EL MONTE UNION HIGH SCHOOL DISTRICT

April 26, 2023

TO : All Bidders
FROM : El Monte Union High School District
BID # : 2022-23(B8)
PROJECT : Mountain View HS Modernization Project
SUBJECT : Addendum No. 6

1. LPA Architects Addendum No. C issued April 26, 2023 attached.

MATERIALS
PLAN

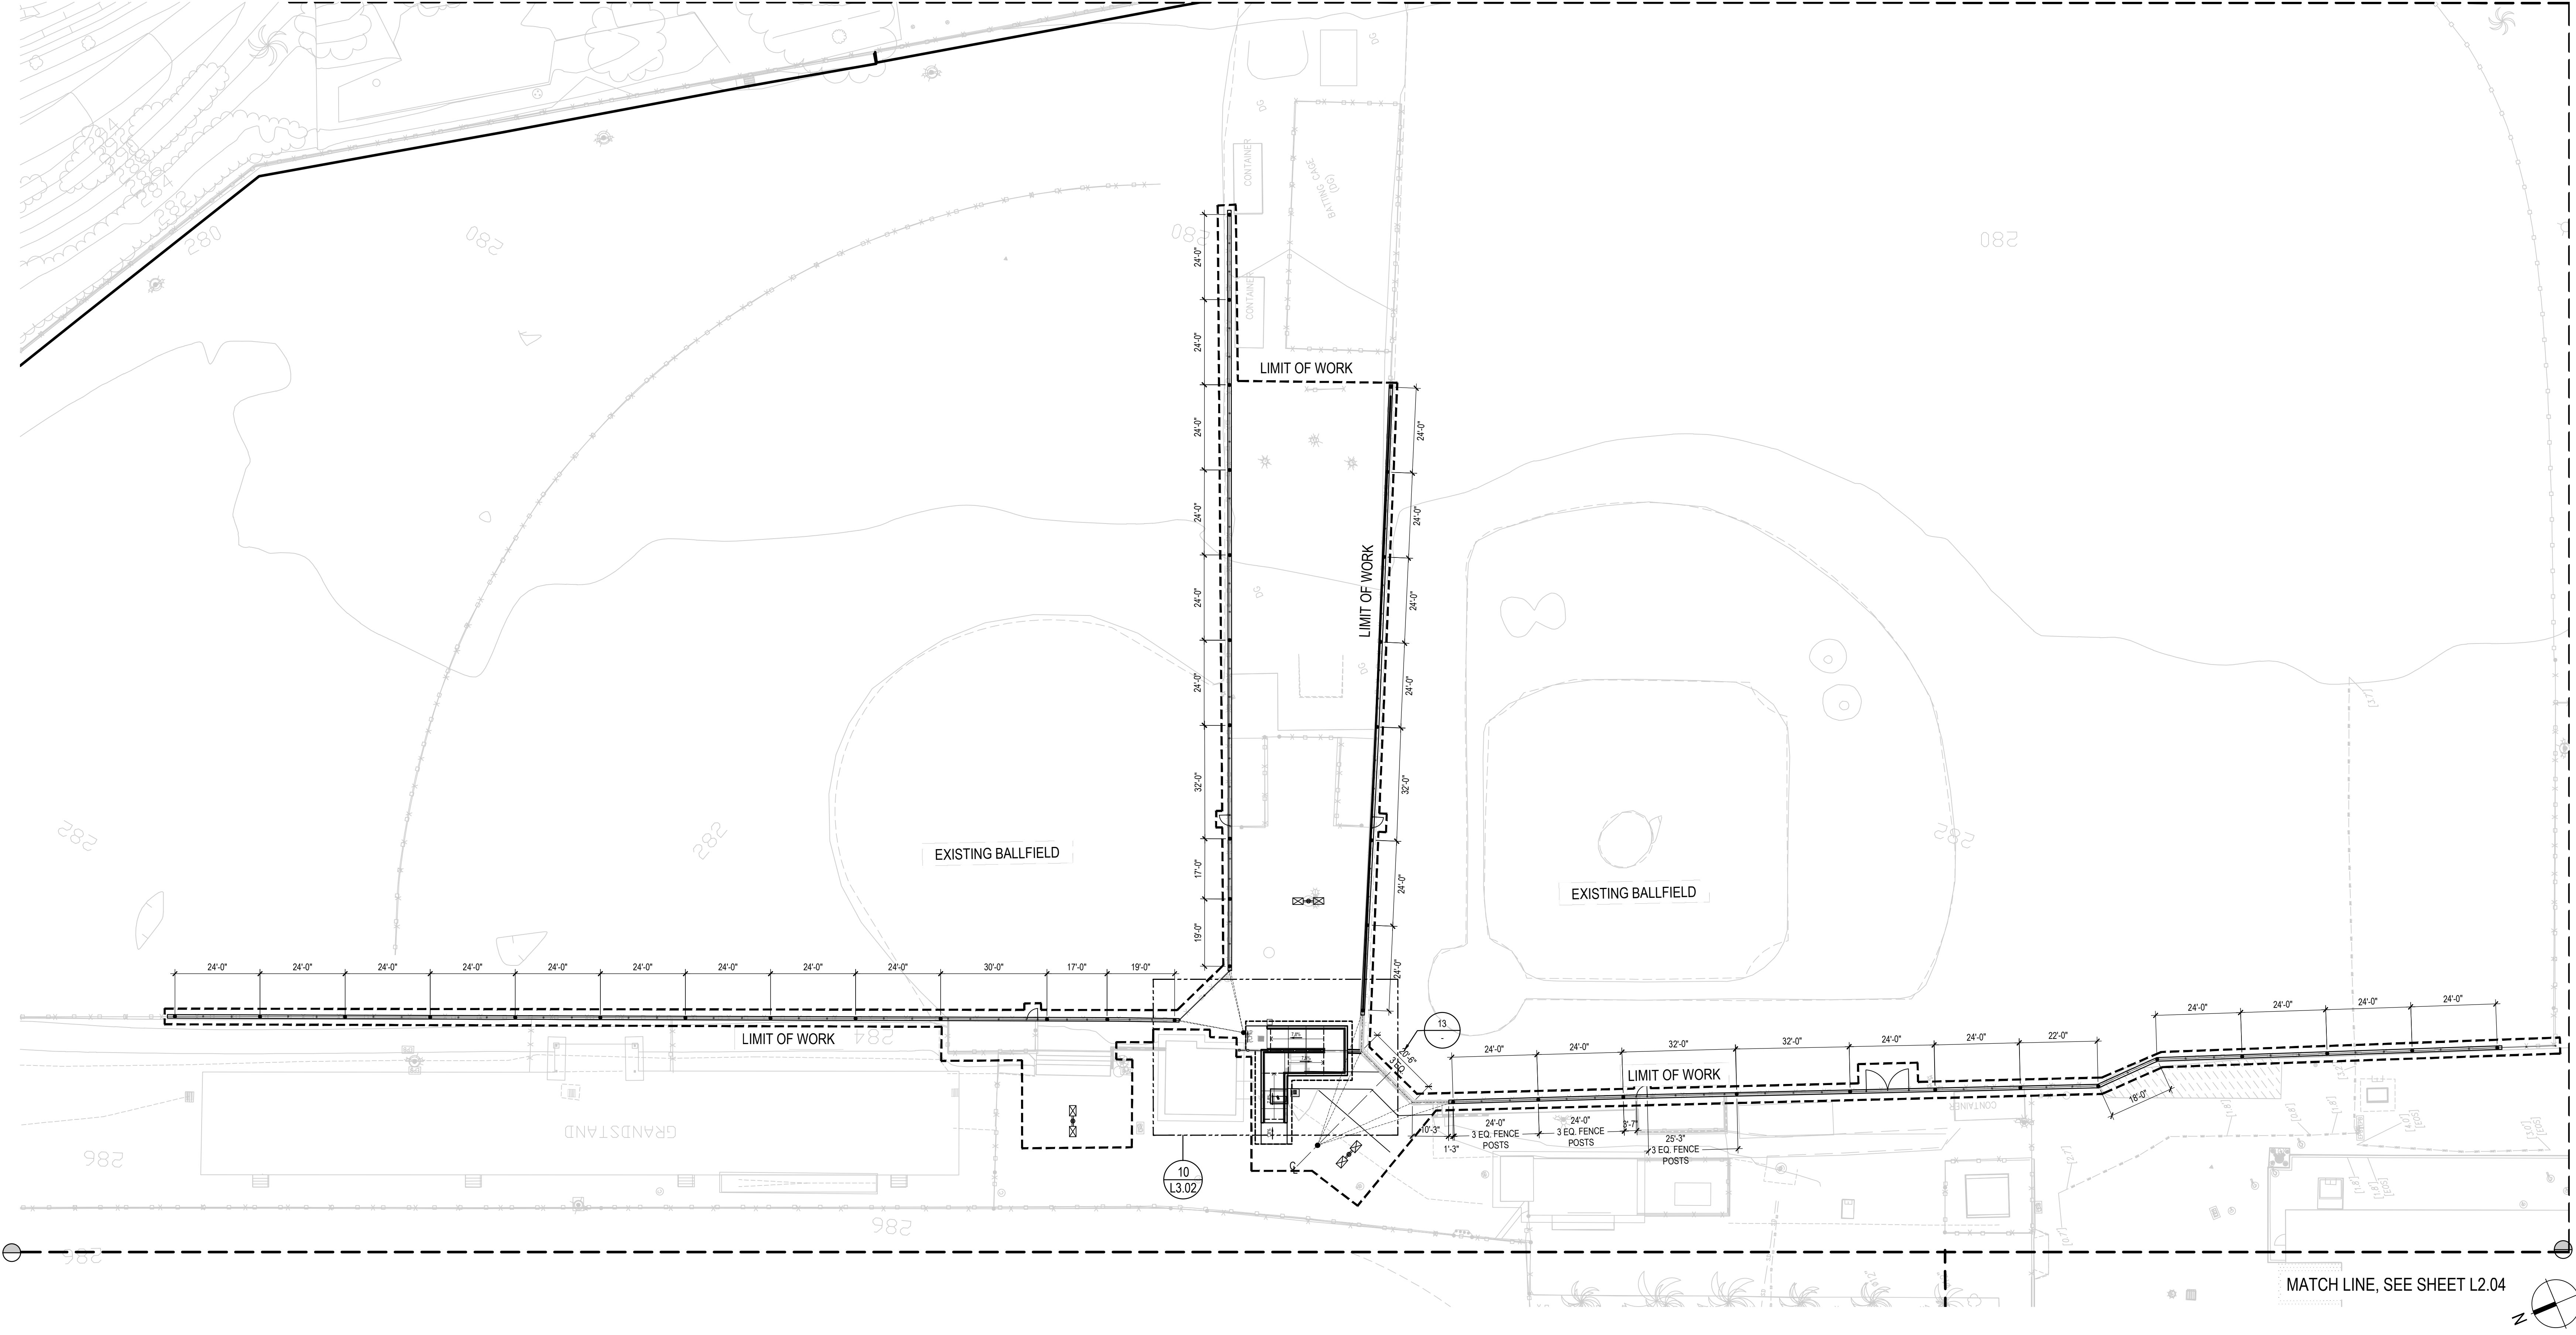
Item No. 12 **Sheet L1.02 – Materials Plan**
(a) Updated gate type

LAYOUT PLAN 1" = 20'-0" 02

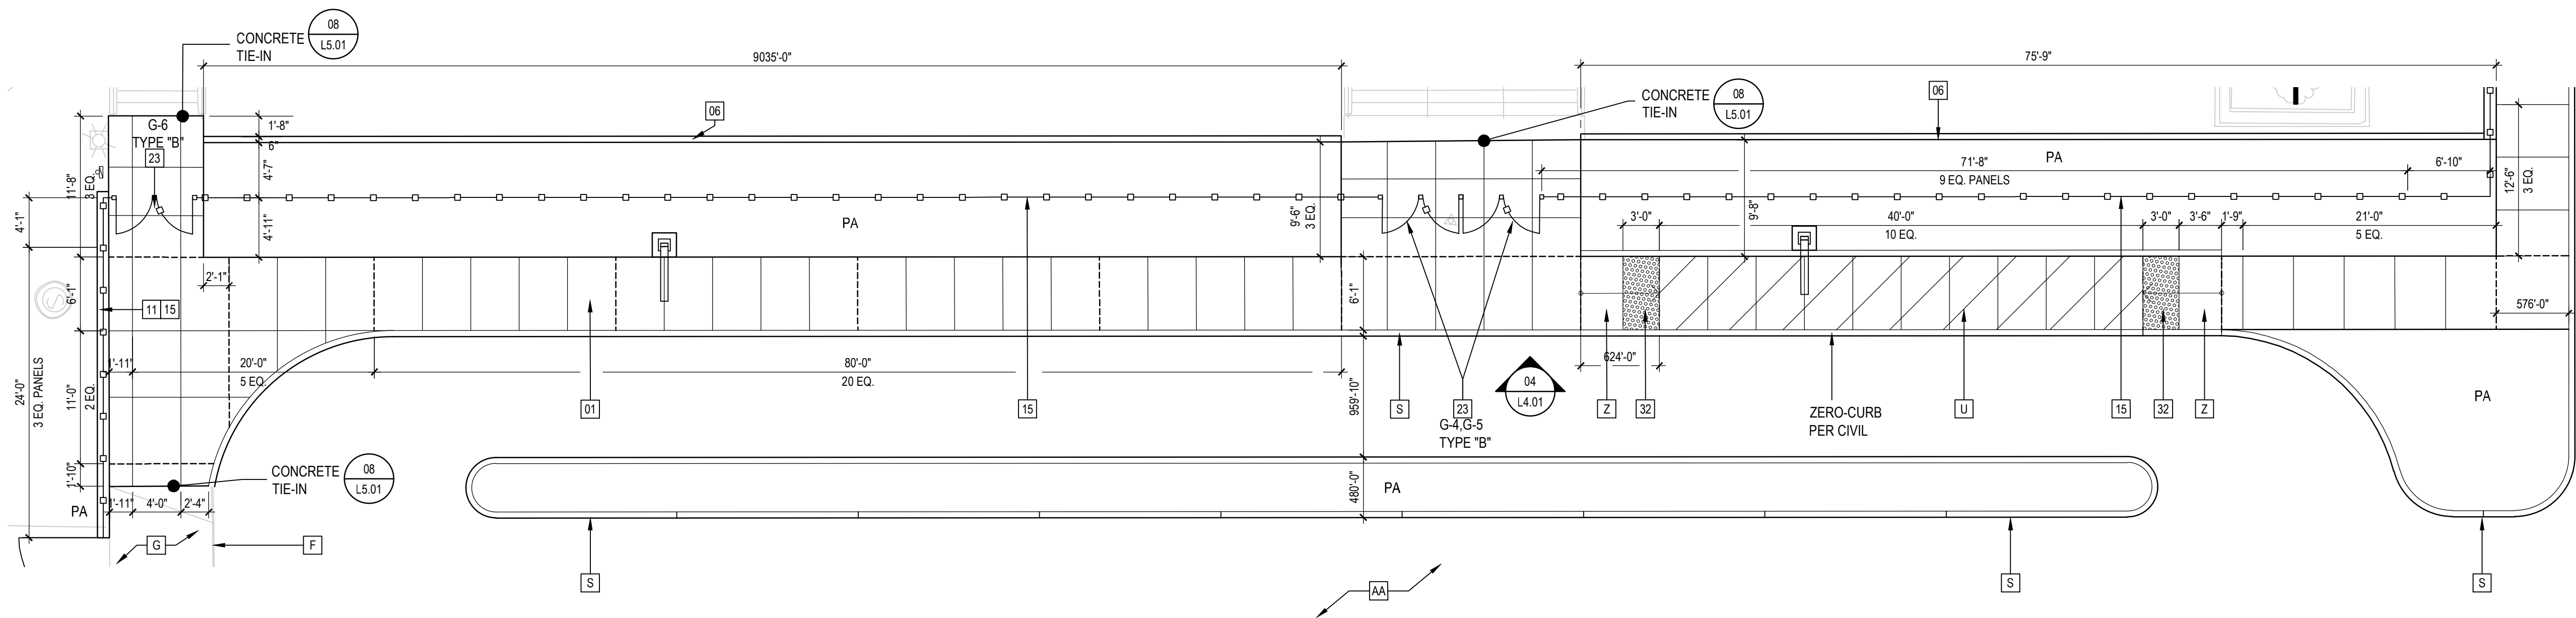
Item No. 13 **Sheet L2.05– Layout Plan**
(a) Added notation stating that Netting poles are to be installed per dimensions on this sheet. Reference Elevations and SportsField Specialties sheet for more information.

NETTING POLE DIM. LAYOUT IS NOTED ON THIS PLAN,
FOR ADDITIONAL INFORMATION SEE ELEVATIONS L4.02 AND L4.03,
AND SHEETS SFS-1 TO SFS-3

DENHOLM DRIVE VEHICULAR ENTRY

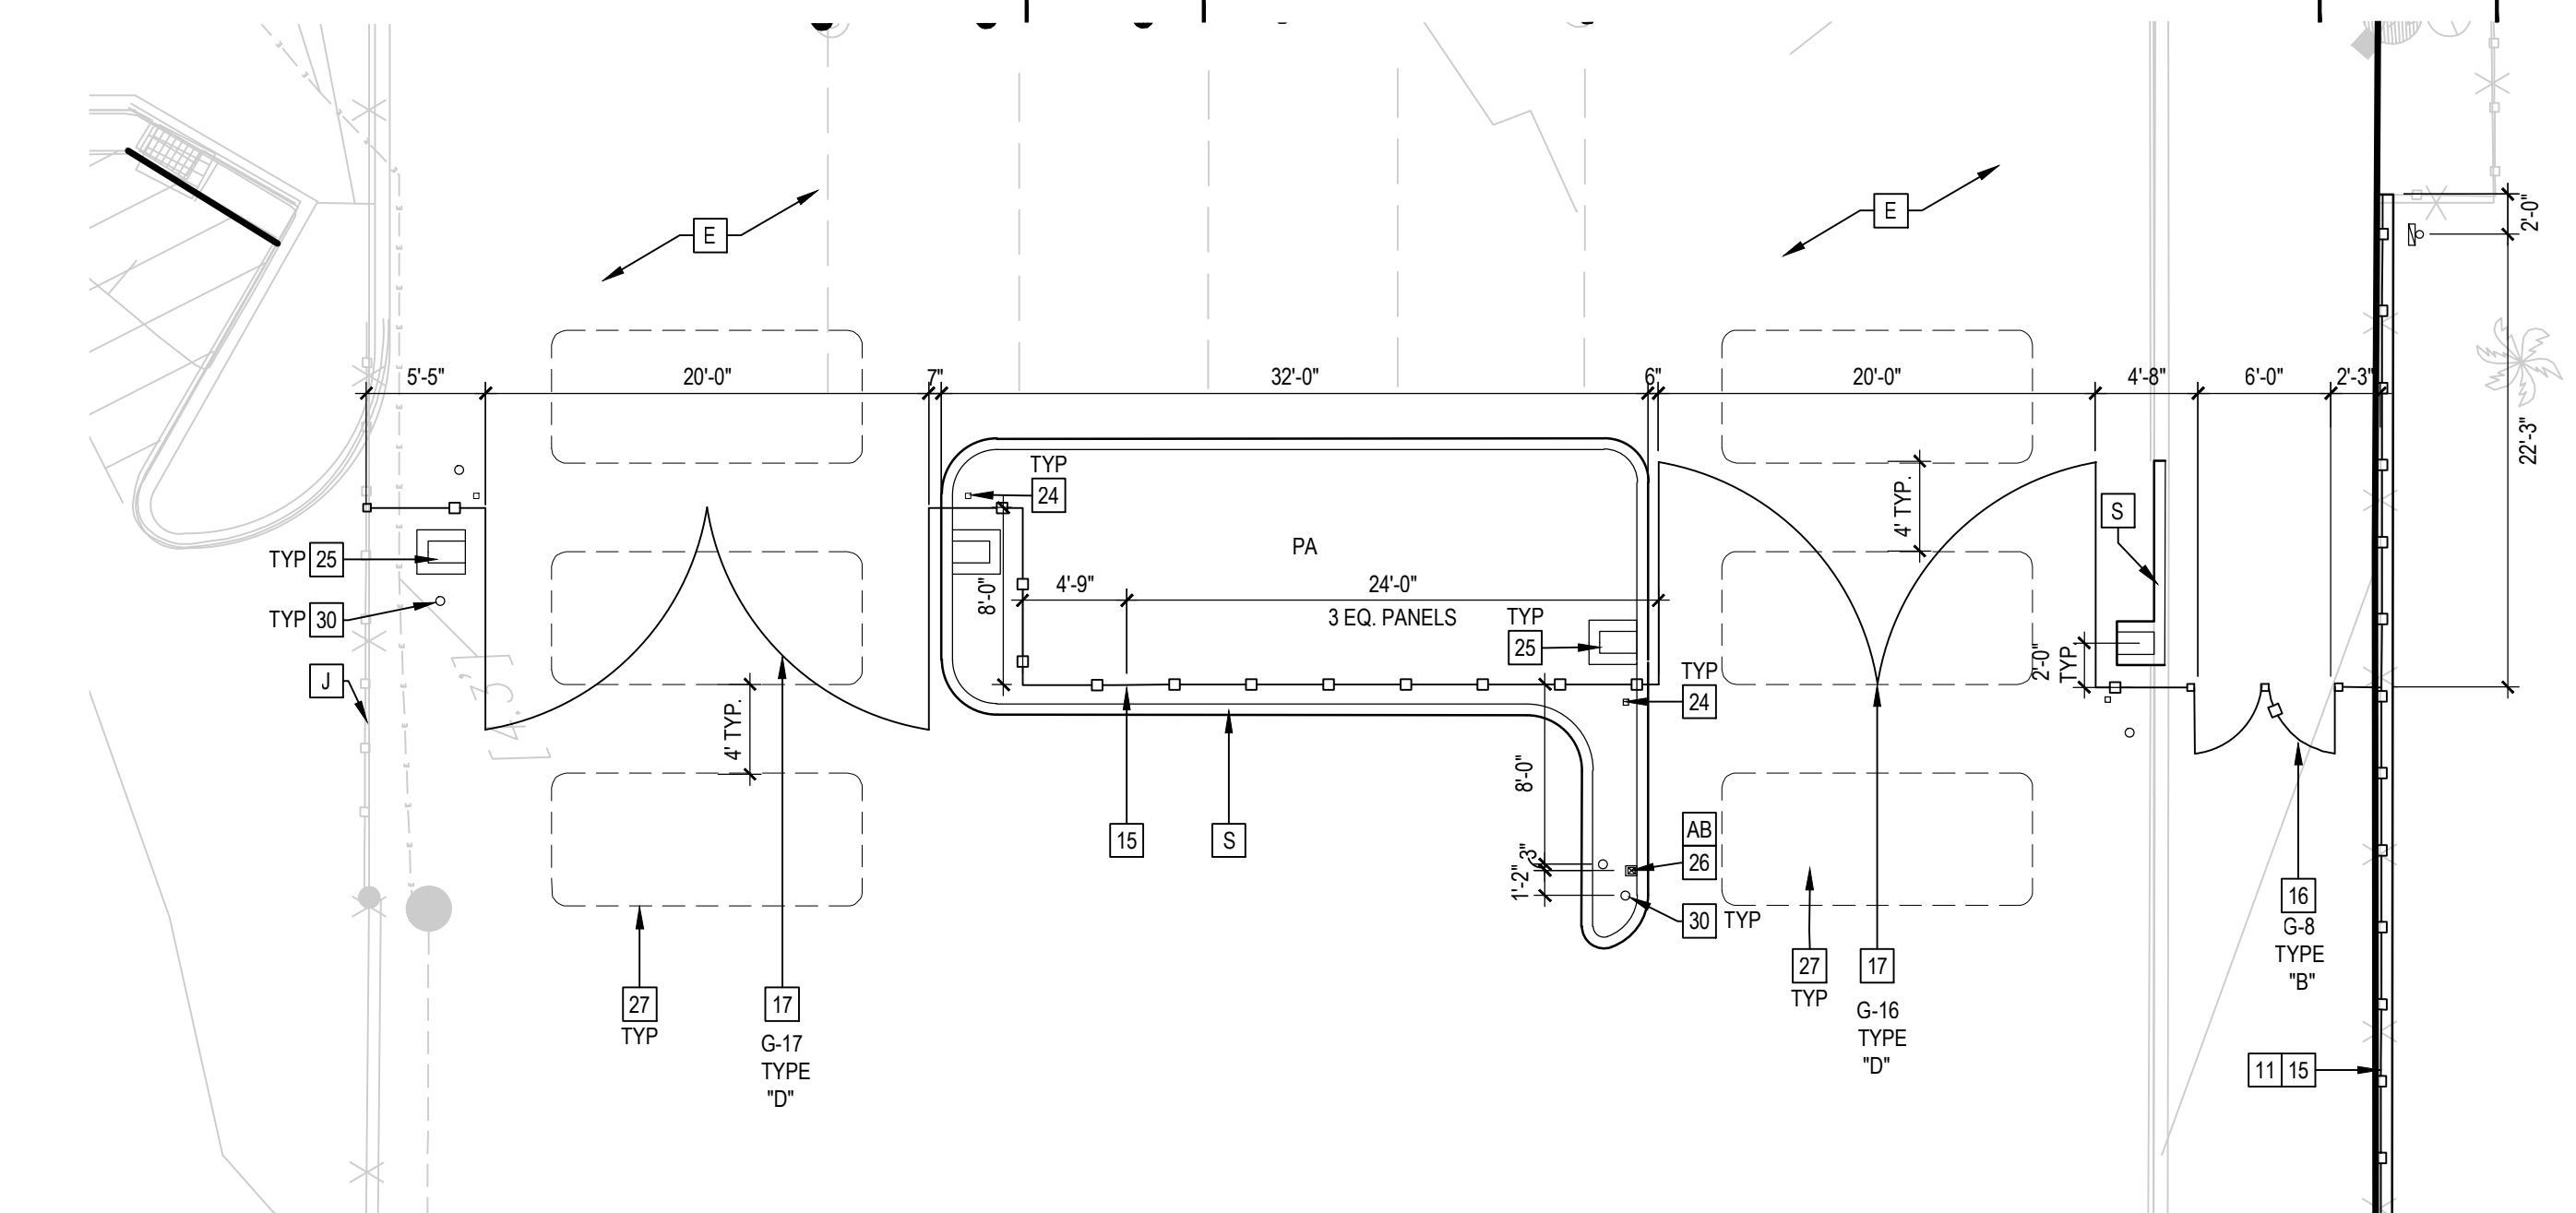
Item No. 15 **Sheet L3.02– Enlargement Plan**
(a) Clarification on gate type on detail 06.
